**Re: Air Quality Permit Application, Permit No. 6112
Rosemont Copper Project**

This letter responds to your letter dated September 23, 2010, in which you deemed Rosemont Copper Mining's Class II air quality permit application for the proposed Rosemont Copper Project incomplete. Rosemont Copper Company ("Rosemont") staff and consultants met with Mr. Richard Grimaldi, Mukonde Chama and Rupesh Patel of your staff on October 1, 2010, together with Ms. Leslie Lukach of the Pima County Attorney's office, to discuss the information and gain additional insight on what information is needed. We appreciate their availability to meet with us.

FIGURE 1
LAND POSITION MAP
ROSEMONT COPPER PROJECT

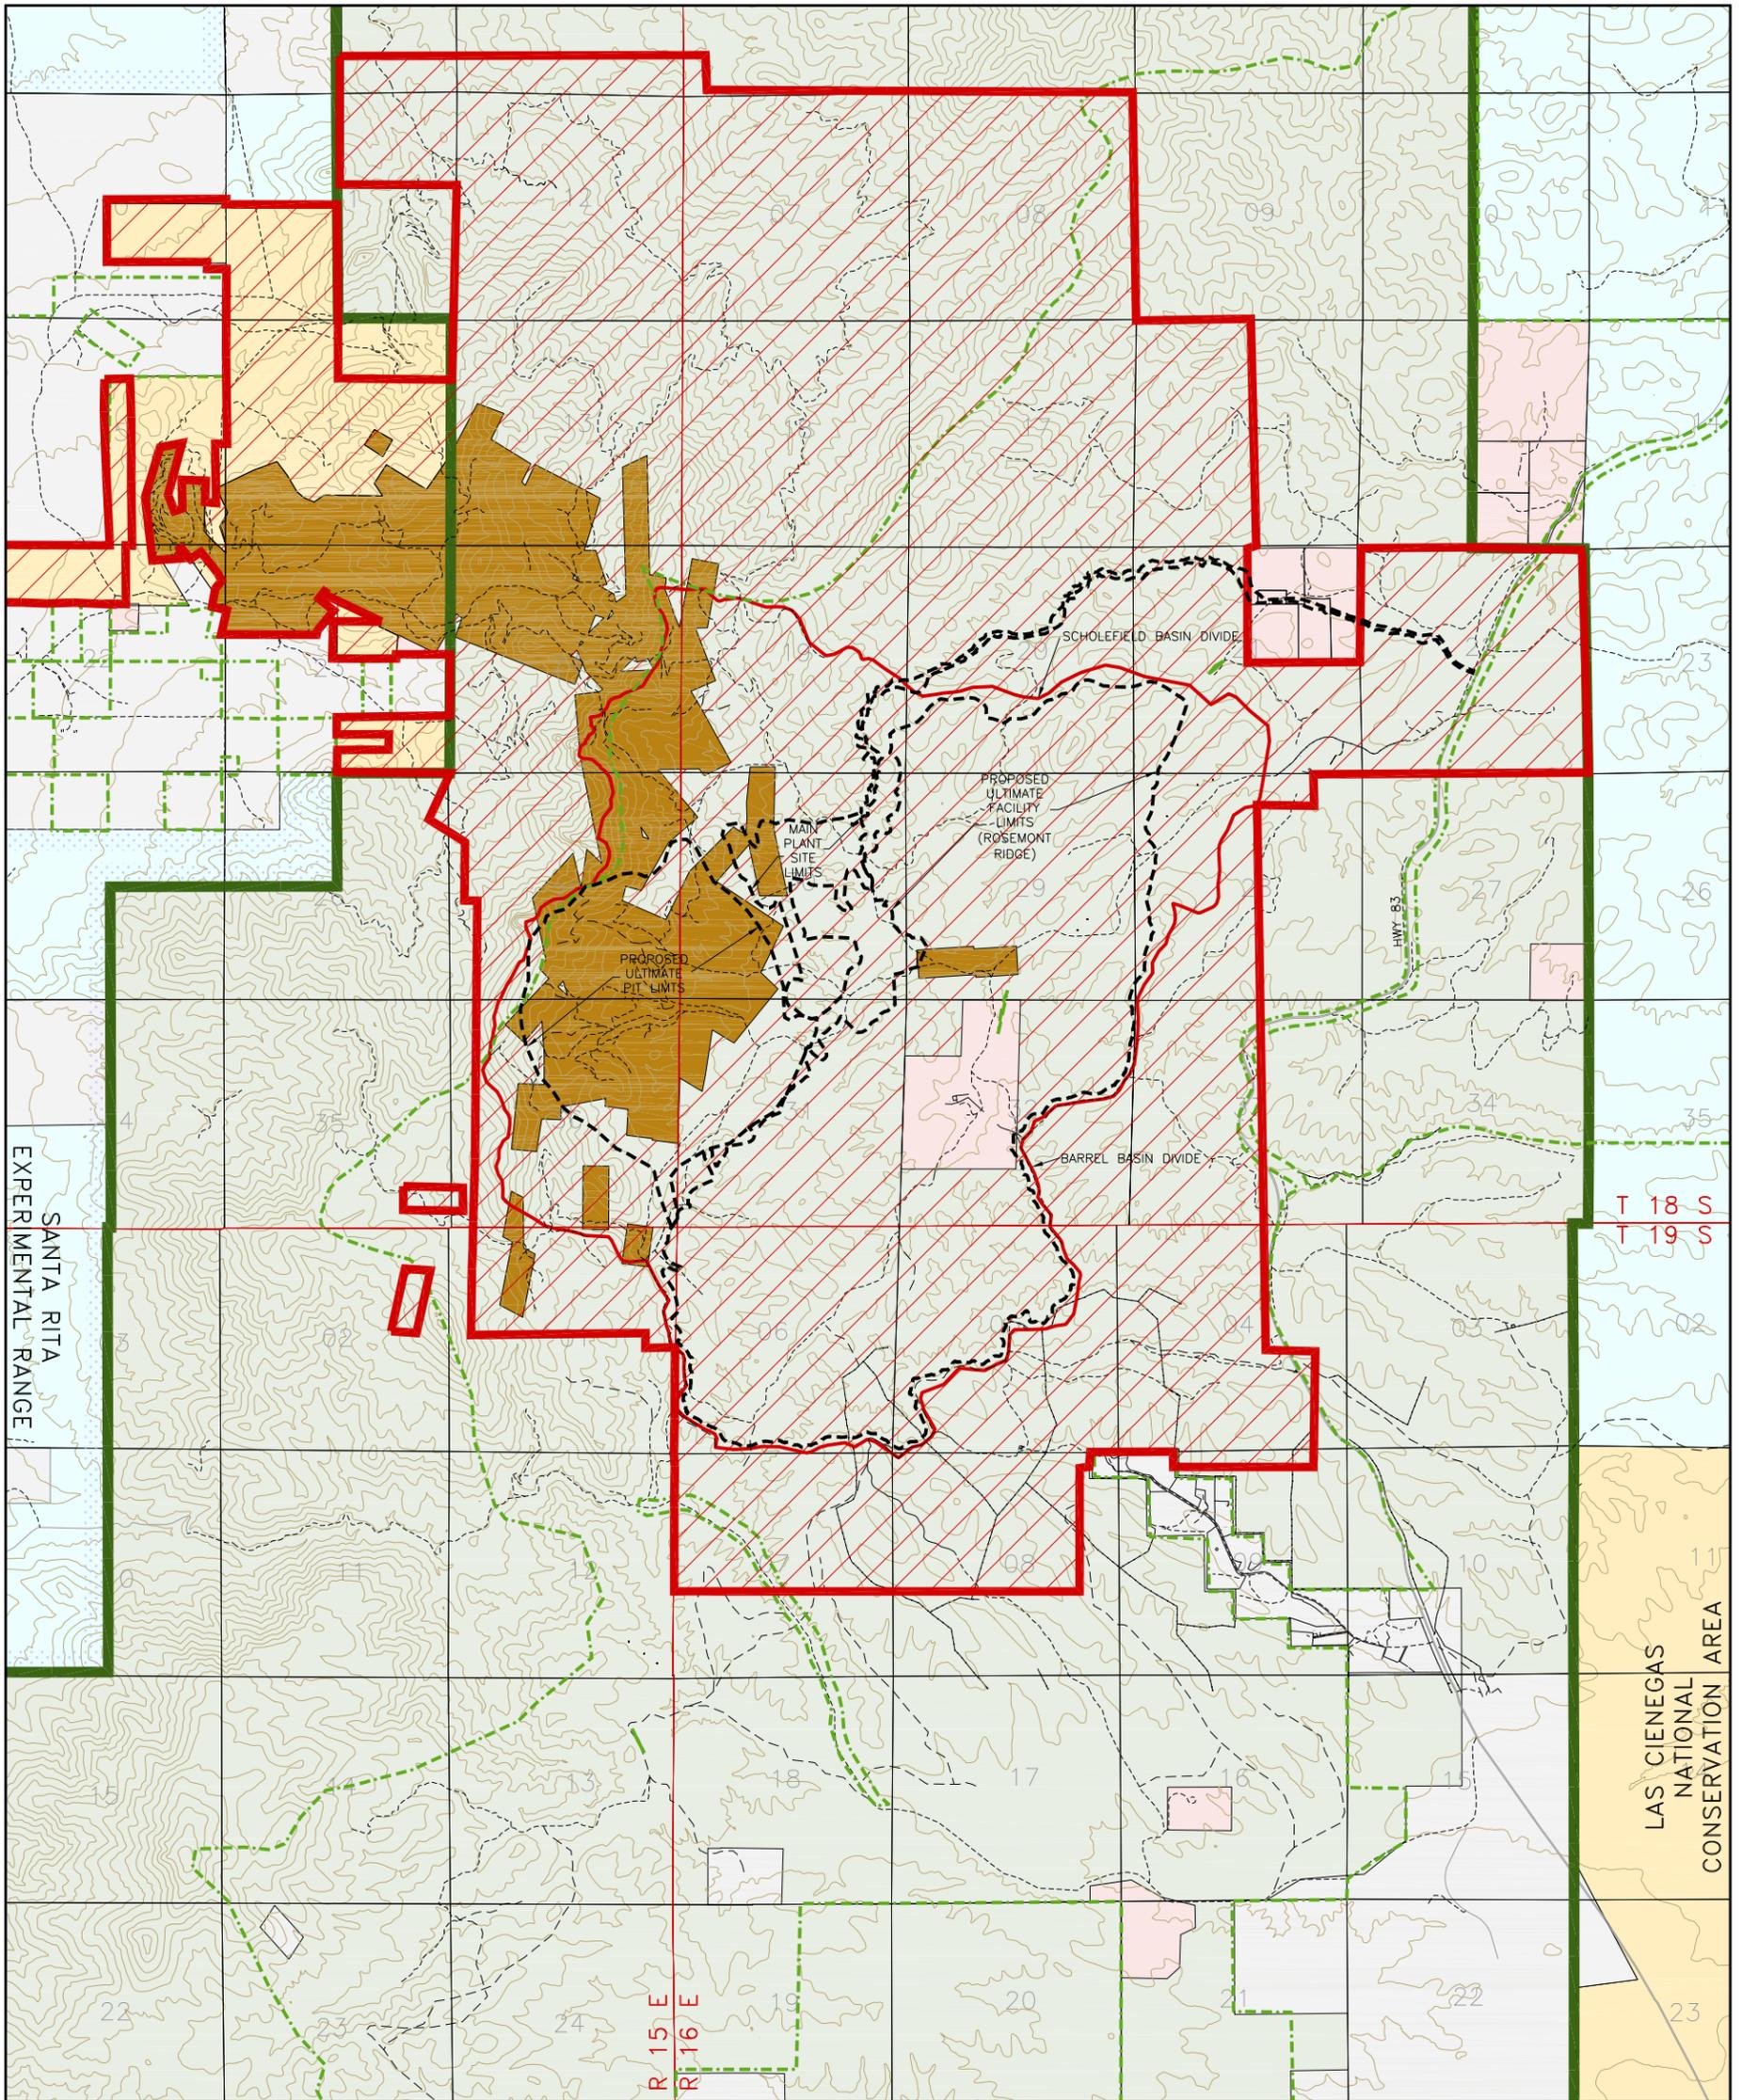
A. Identify which parts of the proposed RCM mine will be on private and federal lands;

Rosemont has attached as Appendix 3 the EIS “boundary map” showing the land ownership and administrative land control authorities over its proposed project area. Rosemont will have full operational control over areas within the project boundary. Accordingly, underlying land ownership should not affect permit requirements or permit processing.
